Delmore Fast Track Application

Appendix 8: A13 (Wastewater) to Response to Comments letter

Re: Response to Annexure 13 to Auckland Council Response – Wastewater

Figure 1 – Concept design of the infiltration trench used to provide land contact to discharges prior to entry into the unnamed tributary. (Calthom Consultants, 2021)

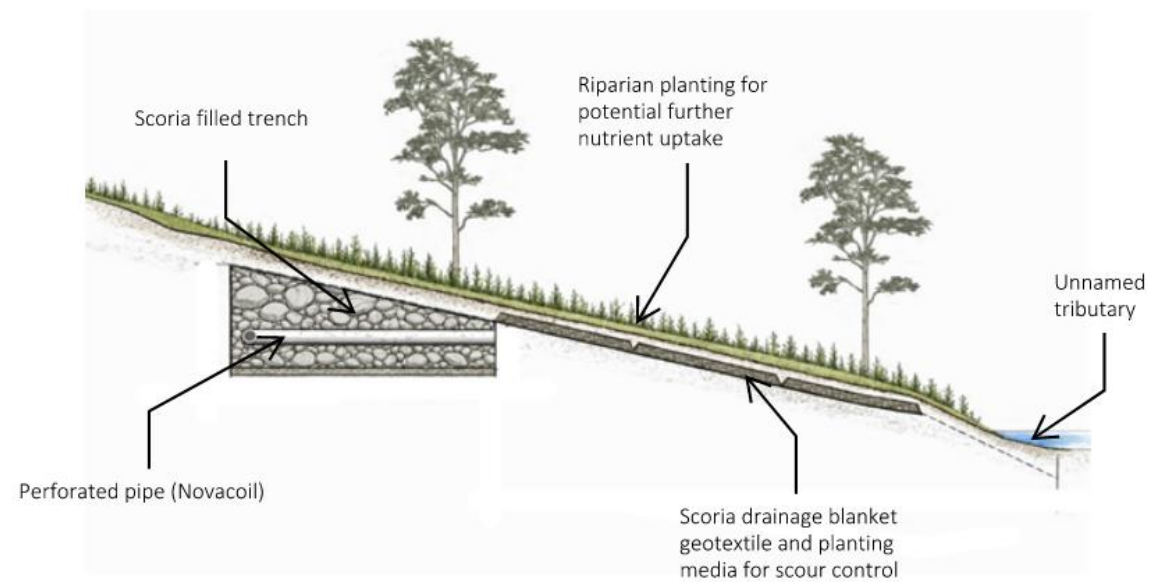
Information Request from Council on the lodged material	Applicant Response	Information Request / Technical Comment from Council under section 53 FTAA	Applicant Response under Section 55 FTAA
No concept design for wastewater disposal trench has been provided.	Apex: A concept design for the treated effluent disposal trench is attached as Appendix A .	Accepted.	Resolved.
No concept design for wastewater irrigation field has been provided. A detailed design is not required, but the level of information on the disposal field currently provided is not sufficient.	Apex: A concept design for the wastewater irrigation field is attached as Appendix B .	Accepted.	Resolved.
No field investigation (hand augers or surface assessment) for proposed disposal field.	Riley: Across the site we have drilled 85no. hand auger boreholes, excavated 53no. test pits and drill 6no. deep machine boreholes. A number of them are near or immediately adjacent to the areas identified for effluent disposal. Overall, we consider that the number and spread of the investigation test locations provides an appropriate level of coverage for assessment of the soil soakage category for the site in terms of GD06. The locations of the investigations in relation to the wastewater disposal	Accepted.	Resolved.

A concept design for a treated effluent disposal trench was designed by Calthom Consultants for the Karaka North Village land development project and has been shown in the figure below. The concept that this trench design is based on is well suited to the Delmore site as it does not rely on infiltration through the native soils but rather provides a naturalised and discrete discharge pathway allowing flows to enter the local unnamed tributary.

The trench consists of two separate parts, (i) the trench itself and (ii) the drainage blanket that extends from the edge of the trench down to the edge of the unnamed tributary. When the underlying soils are unable to assimilate flows into the trench, it shall overfill beneath the surface before diverting down through the drainage blanket. The drainage blanket, installed beneath the surface as a part of riparian improvement works provides a naturalised discharge pathway where discharges can enter the unnamed tributary without requiring a physical pipe, or other discharge structure. This allows the discharge to have minimal impact on the natural environment while also making the treated wastewater available for uptake by planting within the riparian zone.

The figure below shows a conceptual design for this infiltration trench and drainage blanket. Site topography, slope stability and various other geotechnical considerations will be confirmed prior to detailing a suitable design for construction.

Appendix C: Geotechnical Investigations in relation to Wastewater Disposal Areas

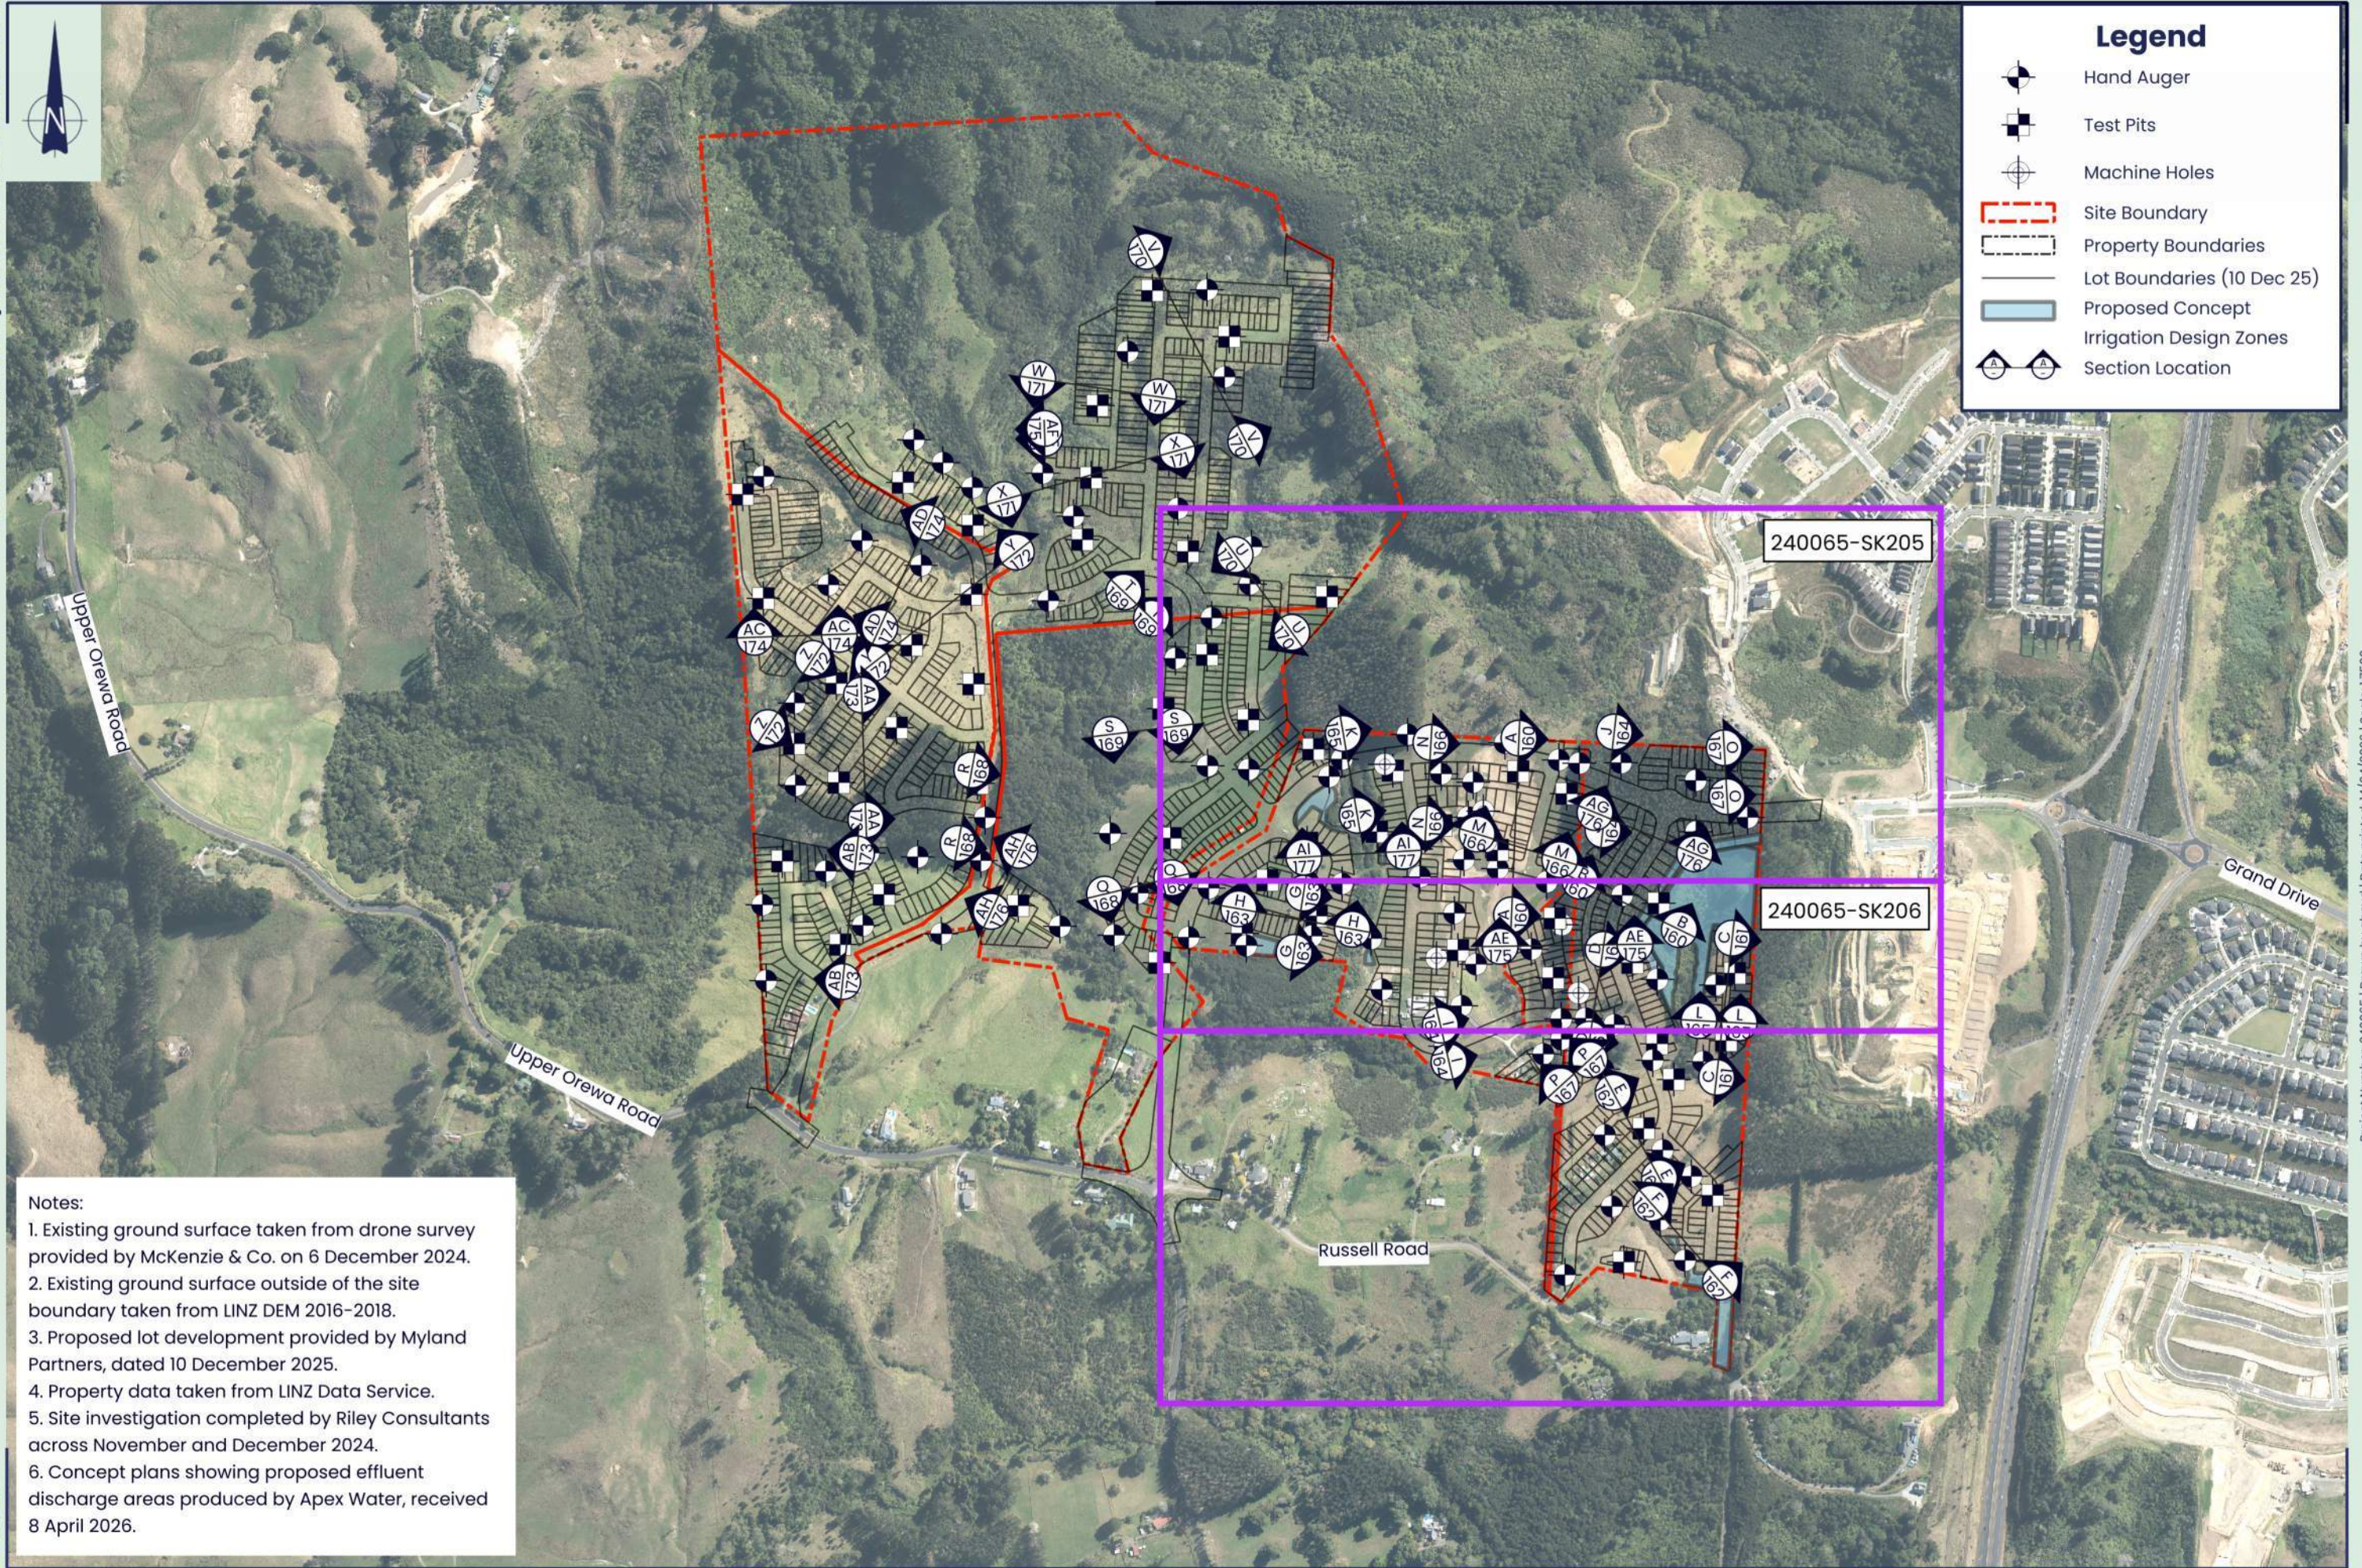
areas are depicted in Appendix C of this memo.		
Confirmation that the peaking factor for the LPS, not the infiltration peaking factor, but instantaneous flow rate of the LPS system has been accounted for in the design of the wastewater treatment plant.	Apex: The treatment plant design has considered the instantaneous peak flow rate within the design of the treatment train. Specifically, the membrane bioreactor is decoupled from the incoming flow through the inclusion of a raw wastewater balance tank.	Accepted.	Resolved.
The Apex report states that the irrigation field will be installed as follows: <i>The installation of the surface drip irrigation line shall be carried out in both newly developed and earth worked areas, as well as in existing bush.</i> Can the applicant provide details of how this area shall be managed so that the disposal field will not be installed in areas that are compacted and no longer suitable for wastewater irrigation?	Apex: The design cut / fill contours have been presented alongside the proposed irrigation areas. By comparing these two drawings, it can be seen that the proposed irrigation zones fall in areas that generally require removal of material to achieve the final development levels. Zones E and H are the exceptions which require both localised cut and fill to achieve the final design levels. In areas requiring cut to achieve final development levels, prior to the placement of topsoil the area shall be inspected for compaction caused by the movement of plant and smearing caused by scraping or contouring areas. Where identified these areas shall be lightly scarified / ripped to	Accepted. This needs to be reflected in an appropriate condition. <i>Prior to installation of any wastewater disposal lines within the disposal field, all areas of cut, fill, or otherwise disturbed ground within the proposed disposal area shall be identified and assessed by a suitably qualified and experienced person.</i> <i>Where wastewater disposal lines are proposed to be installed within areas of cut or fill, those areas shall be remediated to ensure that soil structure, permeability, stability, and wastewater treatment and dispersal capacity are suitable for the proposed onsite wastewater system.</i> <i>Remediation shall include, as a minimum:</i>	Now considered resolved, as per attached email correspondence with Council. This condition has been accepted. Refer to Condition 6 of the wastewater discharge permit.
